MECKLENBURG COUNTY
HEALTH DEPARTMENT

APPLICATION FOR A RESIDENTIAL SITE IMPROVEMENT PERMIT/ CONSTRUCTION AUTHORIZATION FOR AN ON-SITE WASTEWATER SYSTEM, NEW WELL INSTALLATION, OR REPAIR OF EXISTING WELL

IMPROVEMENT PERMIT for a RESIDENTIAL ON-SITE WASTEWATER TREATMENT & DISPOSAL SYSTEM

Permit #: **30004958** GWS File #: **44B** Tax Parcel #: **217-081-04**

01 SCHEMATIC SITE LAYOUT SCALE: 1" = 30'

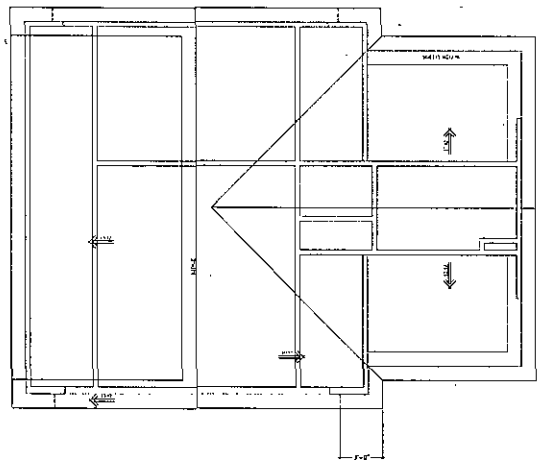
Only garage w/ one bedroom File # 44B to be constructed initialy. Builder will be responsible for achieving gravity from garage to tank at proper depth.

- The septic system shall be located at least 10 feet from any foundation drain.
- Alteration approval for new plot plan . Owner will build garage with living quarters. Plumbing will need to be kept as high as possible.

SHEET TITLE: SEPTIC SYSTEM LAYOUT SKETCH MAP

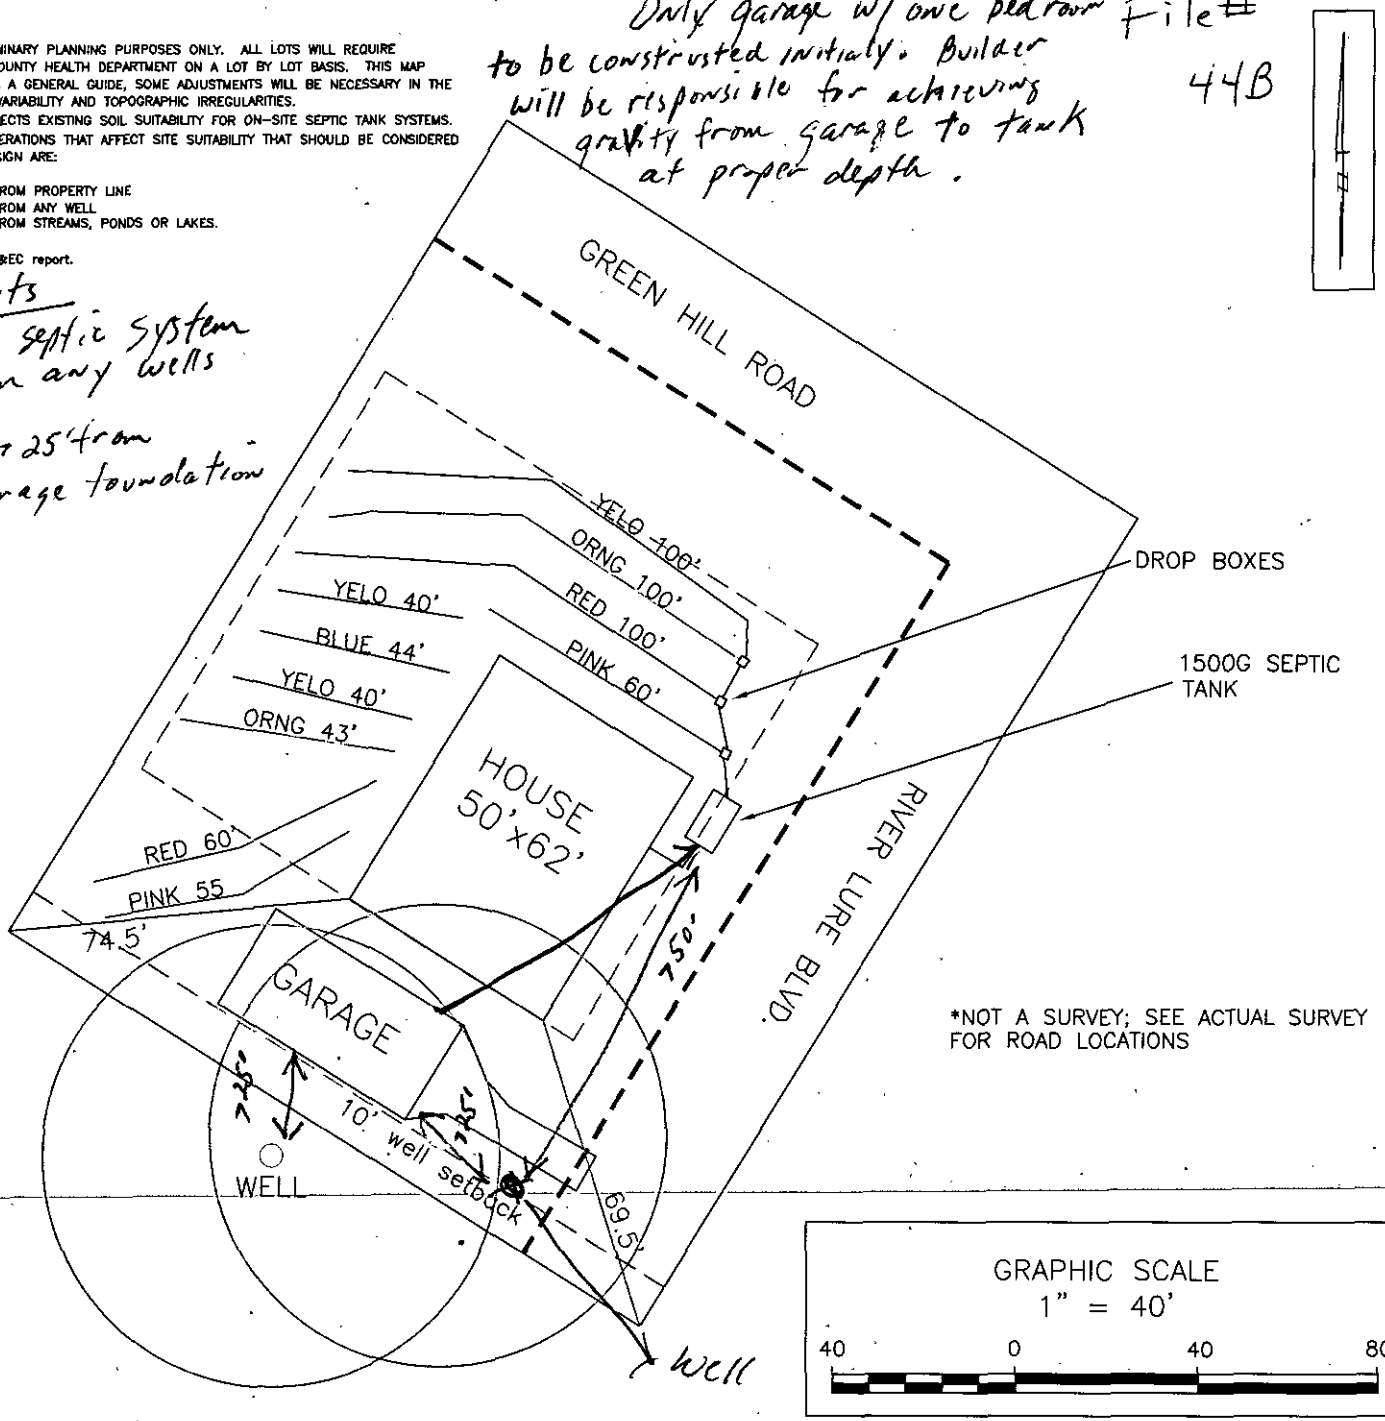
Keep the septic system >50' from any wells

Keep well >25' from house & garage foundation

PROPOSED PLOT PLAN

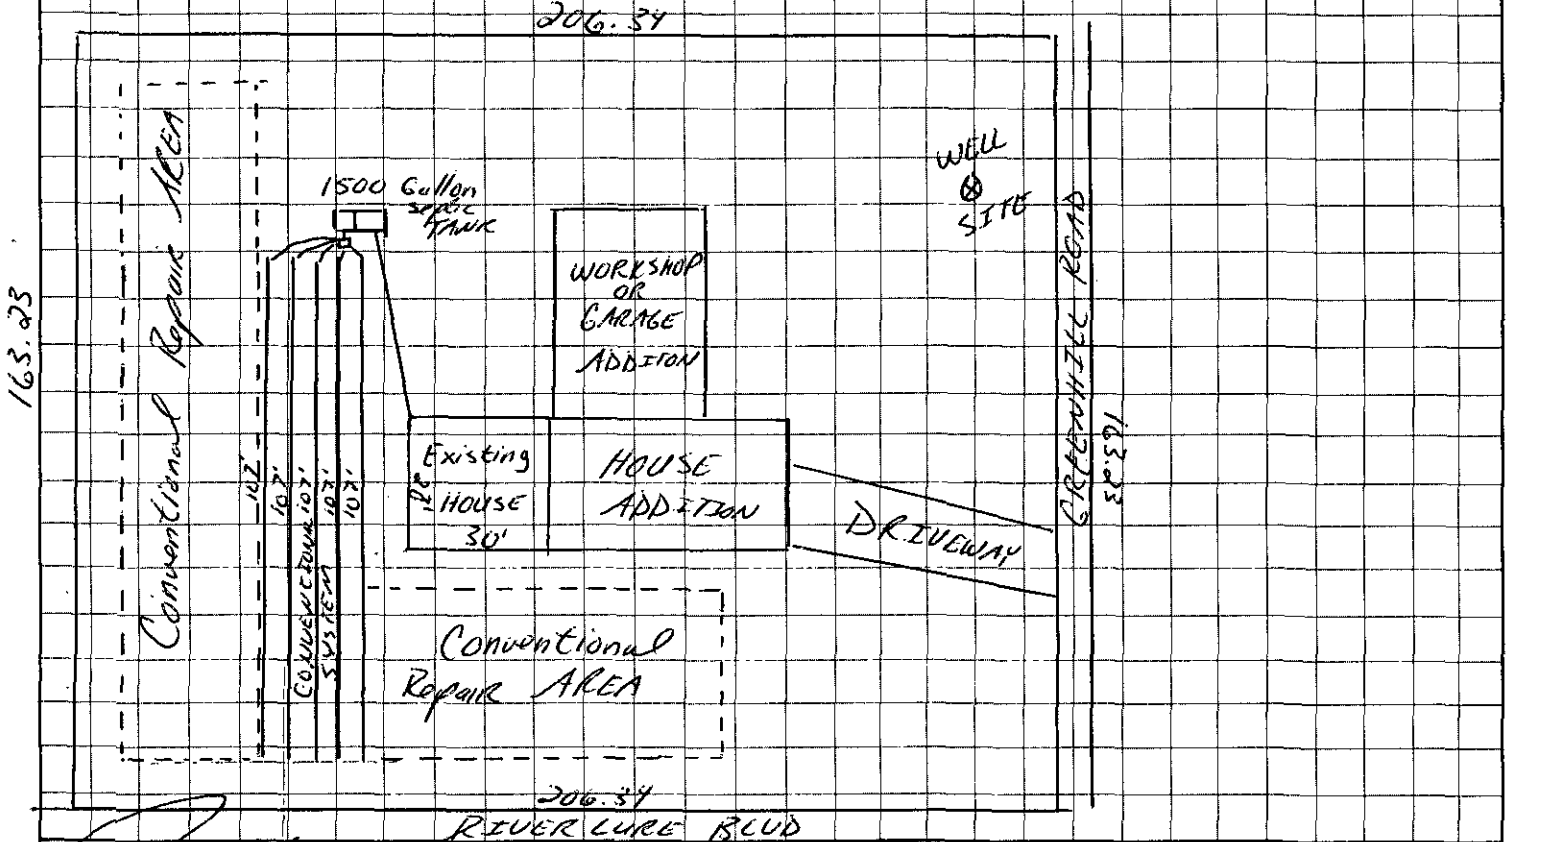
→ System designed for a four (4) Bedroom Residence

→ Install 5 lines x 107' x 3' x 12" Stone

→ Keep well >100' from all parts of septic system
